Transport Assessment Addendum

Anglia Square, Norwich

Iceni Projects Limited on behalf of Weston Homes Plc

A8. ROAD SAFETY AUDIT AND DESIGNERS RESPONSE

Figure 2.3 – Relocated Edward Street Crossing

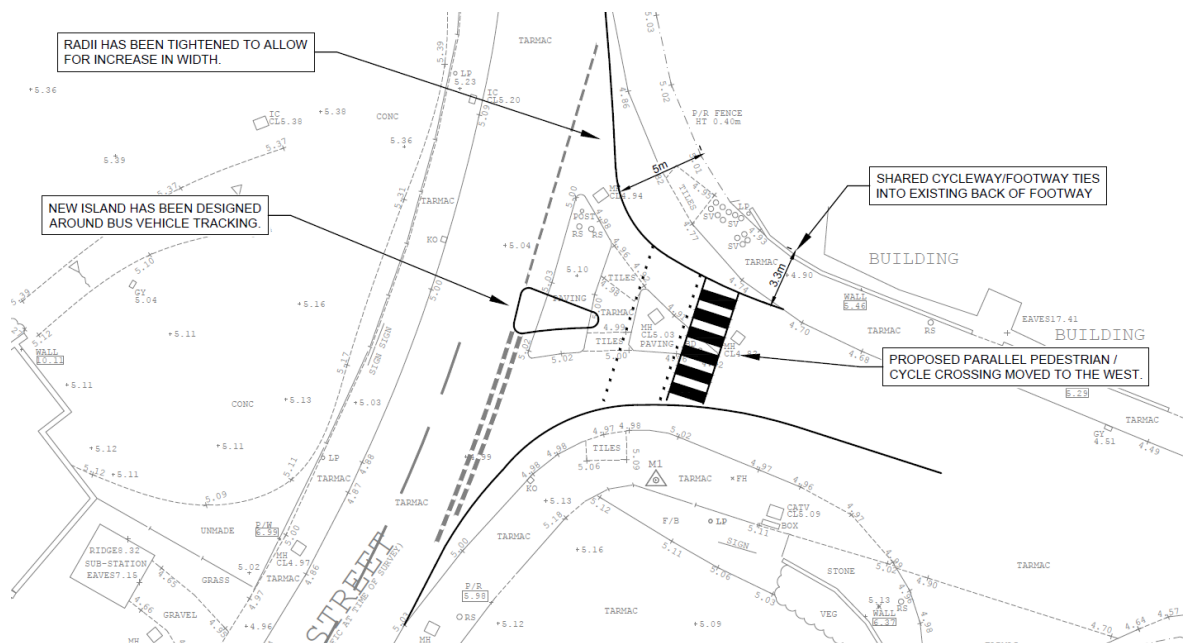
- 2.15 Firstly, on Edward Street (along the main northern site frontage) it has been agreed that crossings are only required at either end of the road i.e. at the junction with Magdalen Street (existing signalised crossing) and at the junction with New Botolph Street (existing crossing which is being upgraded by the proposals). It was advised that the crossing adjacent to Beckham Place was not required and has therefore been removed.

- 2.16 For the Edward Street / New Botolph Street junction crossing, it was agreed between all parties that this should be shifted in a western direction compared to what was previously proposed, albeit it has still been distanced from the junction to allow a car to sit whilst waiting to either exit the junction or head east on Edward Street without blocking the crossing. The updated design / location of this crossing is shown in **Figure 2.3** and in detailed at **Appendix A5**.

- 2.17 The relocated position of this crossing has also allowed the proposed loading bay to shift westwards slightly, which in turn facilitates the single Block A access previously detailed. Despite its slightly different position, the loading bay would continue to operate as described in the TA and updated SPA has been undertaken based on its revised location.

Figure 2.4 – Proposed New Botolph Street Crossing

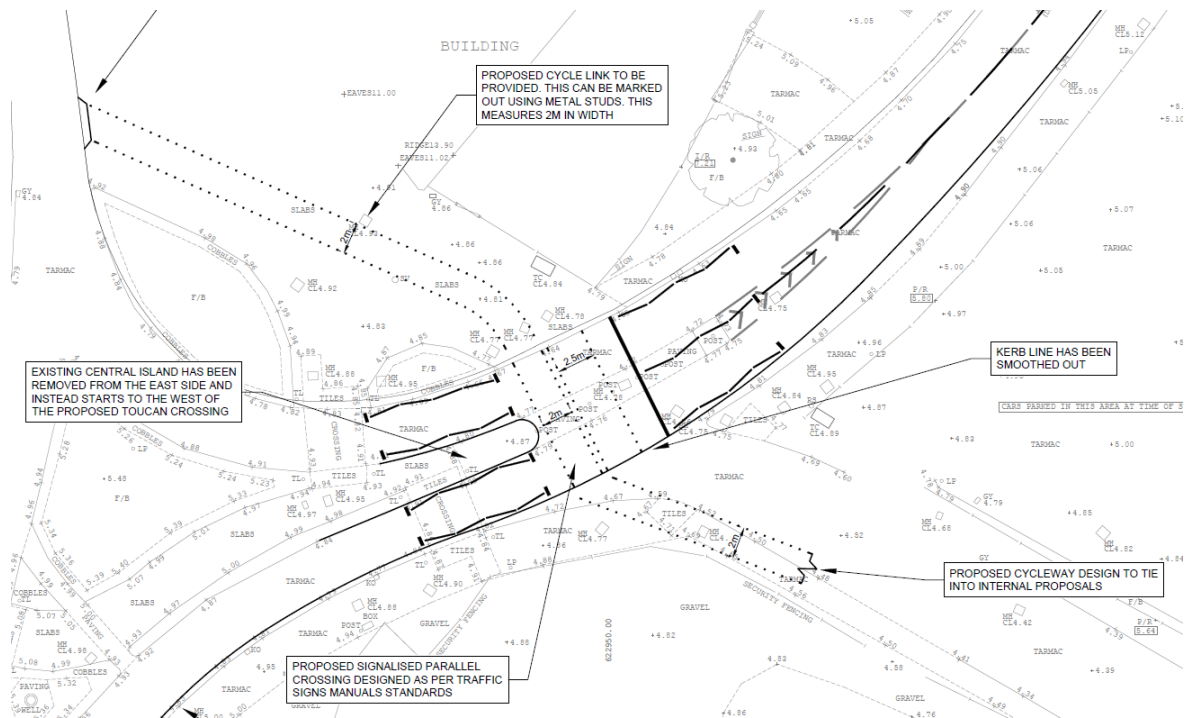
- 2.19 Notwithstanding, an improved crossing facility has instead been proposed, and agreed in principle, on New Botolph Street (just north of Pitt Street). There is currently a signalised crossing broadly in this location, however, it is staggered with a refuge island breaking up the crossing. At the request of NCC / NCoC, what is now proposed is a straight parallel crossing for pedestrians and cyclists with no breaks which will provide a more convenient crossing on what is considered to be an important desire line from the Site to St Augustine's Street. As well as the crossing, it is also proposed to mark out a cycle track across the footway to the west of the crossing, which will follow the desire line across to St Augustine's Church.

- 2.20 Given the proposed crossing will be undertaken in a single phase there is no need to retain the current central island, so this has been removed / relocated to start to the west of the proposed crossing. The design for this crossing is shown in **Figure 2.4** and provided at **Appendix A6**.

Figure 2.5 – Proposed Magdalen Street Bus Stops / Crossing

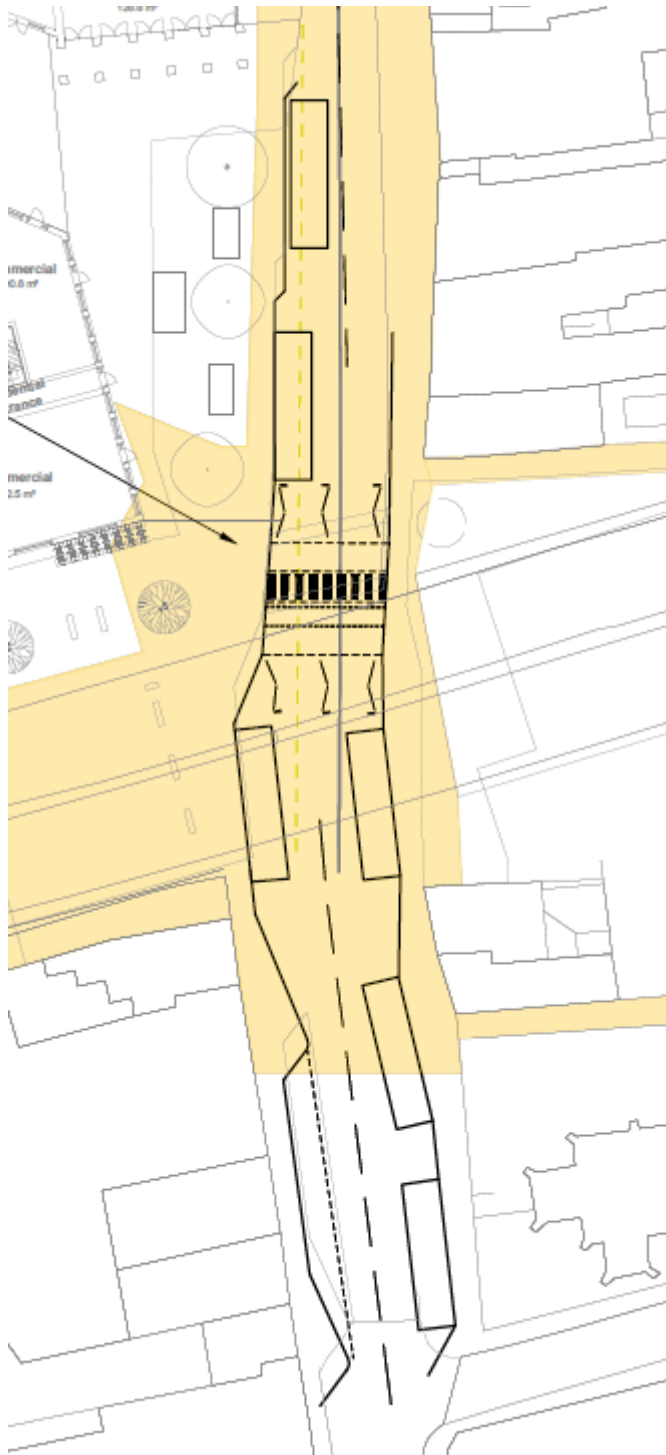
- 2.23 On Magdalen Street, the submitted application made reference to a forthcoming 'Mobility Hub' in this location, however, this would be subject to a separate planning application. However, the NCoC comments highlighted some of these works as being necessary from the outset, and this has been agreed in principle with the Applicant. As such, the detailed design of the bus stop provision and revised kerbs lines, as well as a pedestrian / cycle crossing facility will be resolved via the S106 Legal Agreement.

- 2.24 The crossing previously proposed as part of the Mobility Hub work has been amended so that it crosses the carriageway perpendicular rather than diagonally, at the advice of the NCoC road safety team.
- 2.25 The proposed crossing location and bus stops can be seen on the overall highways plan at **Appendix A4**, but a screenshot is also provided in **Figure 2.5** for reference.

CLIENT			
WESTON HOMES PLC			
PROJECT			
ANGIA SQUARE			
TITLE			
INITIAL HIGHWAYS WORKS			
DRAWN BY	CHECKED BY	APPROVED BY	
AP	RJ	CB	
	17.12.2021	17.12.2021	
SCALE @ A1	DATE		
1 : 1,000	17.12.2021		
PROJECT NO:	DRAWING NO:	REV:	
21-T123	14 (SHEET 1 OF 5)	D

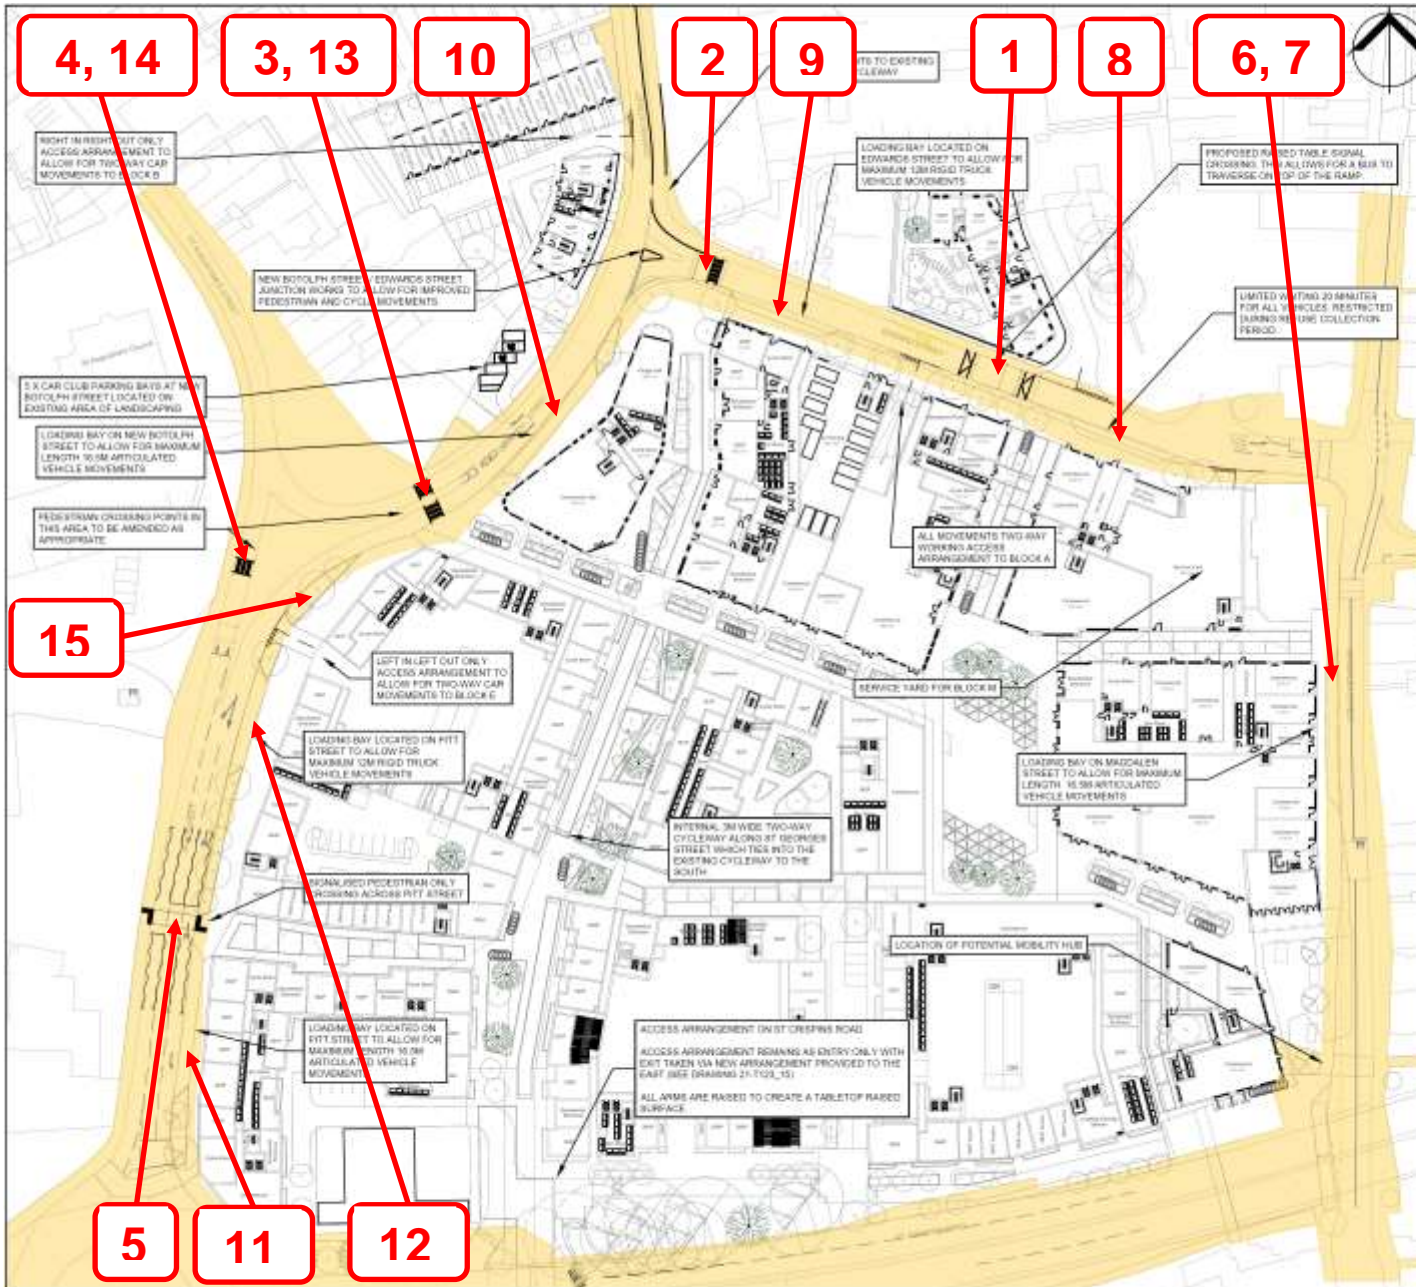
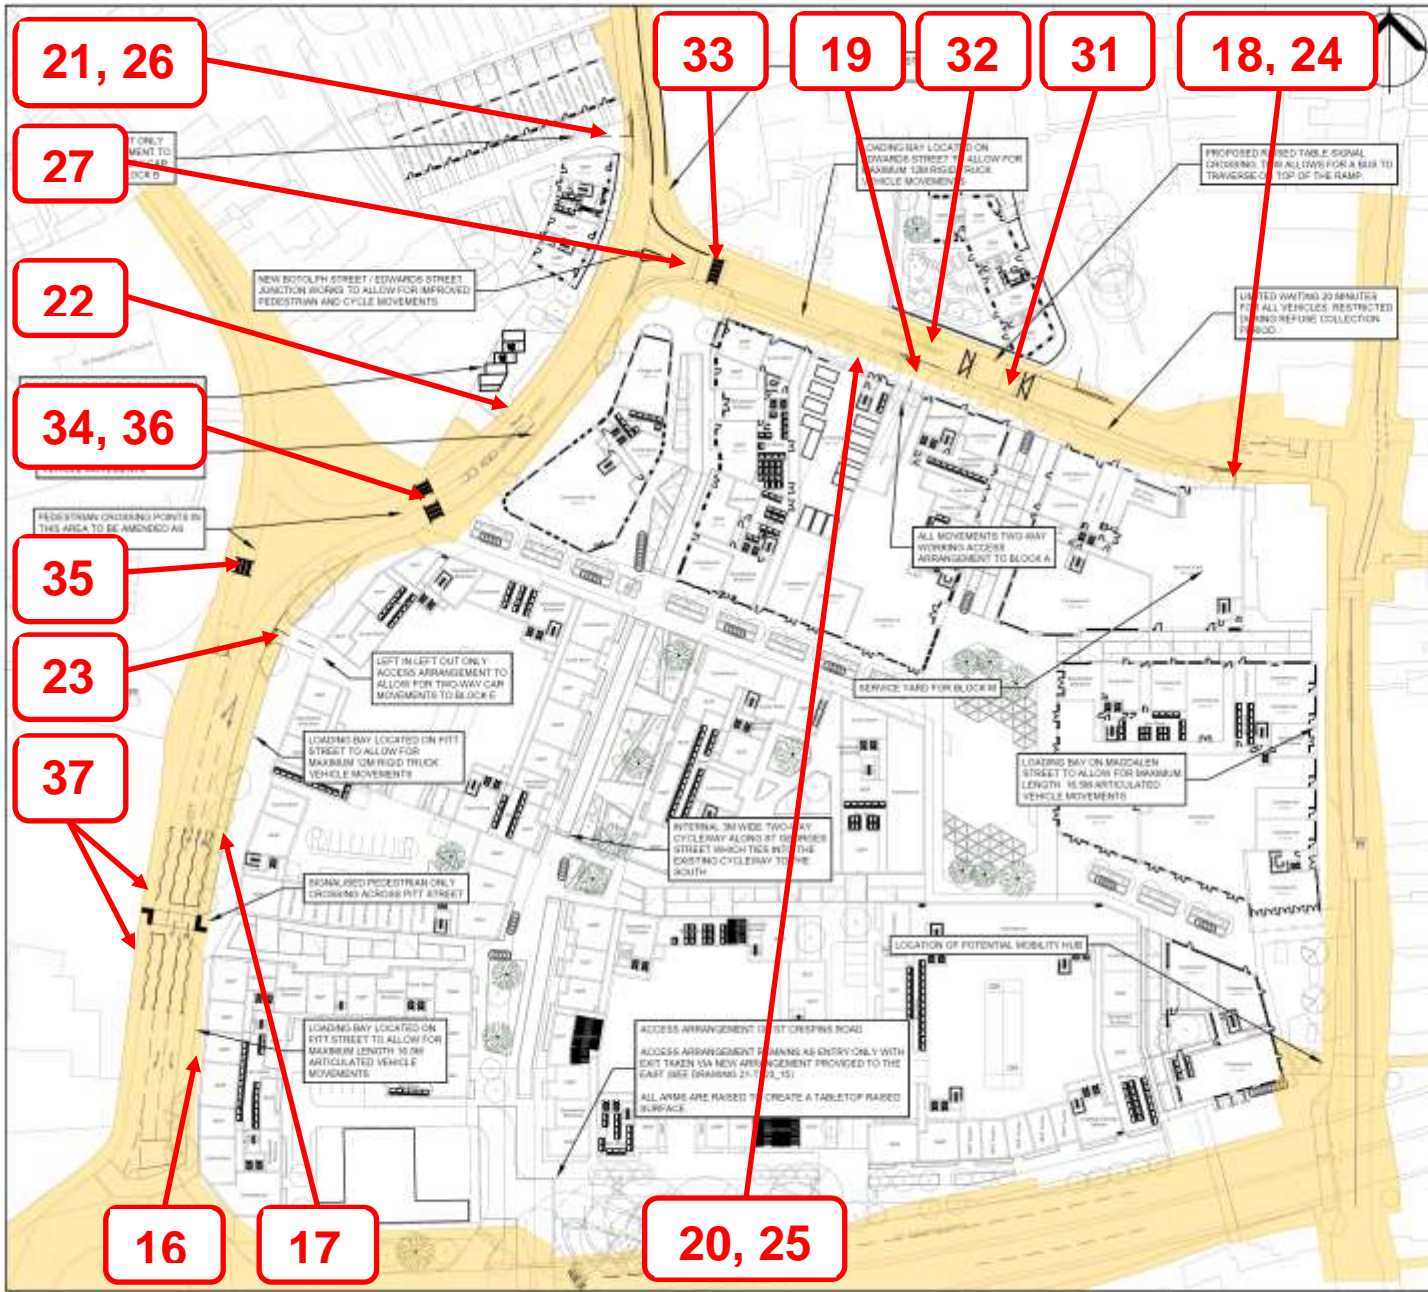
Locations: 1, 2, 3, 4 and 5 - Edward Street, New Botolph Street and Pitt Street, crossing facilities. (Drawing no. 21-T123-14(Sheet 1 of 5) Rev D).

The scheme drawing indicates the provision of signal controlled, parallel and zebra crossing facilities within Edward Street, New Botolph Street and Pitt Street.

Location: 6 - Magdalen Street, loading bay. (Drawing no. 21-T123-14(Sheet 1 of 5) Rev D).

The scheme drawing indicates the provision of an inset loading bay on the western side of Magdalen Street, south of Edward Street.

As a result, restricted forward visibility could lead to a potential increased risk of nose to tail shunt type collisions occurring between a leading vehicle braking heavily upon a change in the signals and any following vehicular traffic on approach to the stop line, whereby vehicle occupants could sustain personal injury.

It is recommended that the forward visibility to the nearside primary traffic signal head should be accurately measured and the scheme drawing updated accordingly. When occupied, should the inset loading bay impact upon the forward visibility at this location, it is further recommended that the inset loading bay should either be truncated southwards or relocated / removed, in order to mitigate the above described potential collision scenario.

Locations: 13 and 14 - New Botolph Street and Pitt Street, existing signal controlled crossing facilities. (Drawing no. 21-T123-14(Sheet 1 of 5) Rev D).

The scheme drawing indicates that the existing signal controlled crossing facilities are to be removed and replaced with zebra crossing facilities on New Botolph Street and Pitt Street.

Location: 15 - New Botolph Street / Pitt Street, proposed trees (Drawing nos. 21-T123-14(Sheet 1 of 5)).

The scheme drawing indicates trees are proposed to be planted on the bend of New Botolph Street / Pitt Street at the location indicated.

Locations: **34** and **35** - New Botolph Street and Pitt Street, zebra crossings. (Drawing no. 21-T123-14(Sheet 1 of 5) Rev D)

The scheme drawing indicates that the existing signal controlled crossing facilities are to be removed and replaced with zebra crossing facilities on New Botolph Street and Pitt Street.

It is recommended that raised tables should be incorporated into the proposed zebra crossing facilities, in order to provide consistency and speed control in this area.

Location: **36** - New Botolph Street, zebra crossing. (Drawing no. 21-T123-14(Sheet 1 of 5) Rev D)

The scheme drawing indicates the existing staggered signal controlled crossing facility on New Botolph Street is to be removed and replaced with a zebra crossing facility further east from its current location.

The scheme drawing also indicates that the zebra crossing is to be split by the existing narrow traffic separation island on New Botolph Street.

Location: 37 – Pitt Street, existing vehicular crossovers (Drawing no. 21-T123-14(Sheet 1 of 5) Rev D).

The scheme drawing indicates a signal controlled pedestrian crossing facility is proposed on Pitt Street.

In order to provide the dropped kerb facility for the tactile paving surface of the signal controlled crossing facility, the two existing vehicle crossovers leading to the parking bays either side of the building may need to be realigned in order to accommodate the stop line and tactile paving.

It is recommended that the existing vehicular crossovers should be indicated on the scheme drawing in relation to the proposed signal controlled pedestrian crossing facility.

Additionally, it is recommended that the existing dropped kerb layout leading to the designated parking bays should be modified to incorporate the dropped kerb facility and controls for the proposed signal controlled pedestrian crossing facility, in order to mitigate the above described potential collision scenario.

RSA problem	RSA recommendation	Design organisation response	Overseeing Organisation response	Agreed RSA action
2.2.1) Edward Street, New Botolph Street and Pitt Street, crossing facilities. Reducing the potential risk of skidding and enhancing braking capacity on the approaches to the proposed crossing facilities located on Edward Street, New Botolph Street and Pitt Street, in order to minimise potential vehicular and pedestrian/pedal cyclist collisions occurring, as well as vehicular collisions occurring, whereby pedestrians, pedal cyclists and vehicle occupants could sustain personal injury.	<p>It is recommended that a high skid resistant surface course material (formerly referred to at the wearing course), should be provided on the approaches to the proposed signal controlled, parallel and zebra crossing facilities.</p> <p>It is suggested that as a minimum, the length of the high skid resistant surface course (formerly referred to at the wearing course), should be based on vehicular approach speeds and recognised stopping distances in the Highway Code.</p>	<p>Noted – correct surface treatment, in accordance with standards, to be provided on approach to all proposed crossings.</p> <p>Details to be provided at Stage 2.</p>

RSA problem	RSA recommendation	Design organisation response	Overseeing Organisation response	Agreed RSA action
2.2.2) Magdalen Street, loading bay. Restricted forward visibility to the nearside primary traffic signal head could result in a potential increased risk of nose to tail shunt type collisions occurring, whereby vehicle occupants could sustain personal injury.	<p>It is recommended that the forward visibility to the nearside primary traffic signal head should be accurately measured and the scheme drawing updated accordingly. When occupied, should the inset loading bay impact upon the forward visibility at this location, it is further recommended that the inset loading bay should either be truncated southwards</p>	<p>Not accepted. The loading bay has been recessed to allow for this. The road alignment on approach to signals fractionally bends in an eastward direction and the position of the driver would be more towards the middle / centre of the road when looking towards the signal heads.</p>

RSA problem	RSA recommendation	Design organisation response	Overseeing Organisation response	Agreed RSA action
2.2.4) New Botolph Street and Pitt Street – existing signal controlled crossing facilities. Lack of signage for motorists with regard to direction of travel and banned turns could result in a potential increased risk of vehicular collisions occurring within the junction area, whereby vehicle occupants could sustain personal injury.	It is recommended that the signage contained with the existing traffic signal heads should be replicated via a post and plate system on the adjacent footways, in order to mitigate the above described potential collision scenarios.	The proposals for this area have been updated following discussions with Norwich & Norfolk Council officers. The proposals now include a new signalised crossing facility on New Botolph Street. Proposed signal heads will include the required signage. Detail to be provided at Stage 2.

RSA problem	RSA recommendation	Design organisation response	Overseeing Organisation response	Agreed RSA action
2.2.5) New Botolph Street / Pitt Street – proposed trees. Restricted forward visibility on the bend could result in a potential increased risk of nose to tail shunt type collisions occurring, whereby vehicle occupants could sustain personal injury.	It is recommended that the forward visibility at this location should be accurately measured and the scheme drawings updated accordingly. Any vegetation falling within the forward visibility should either be removed or relocated, in order to mitigate the above describe potential collision scenarios.	Not accepted – the trees will fall within the inter-visibility and forward visibility splays and as such the canopy will be over 2m in height and the species chosen will be planted in such a way that the trunks do not make a continuous barrier to visibility. As such, this would be no different from a telegraph pole and lamp column.
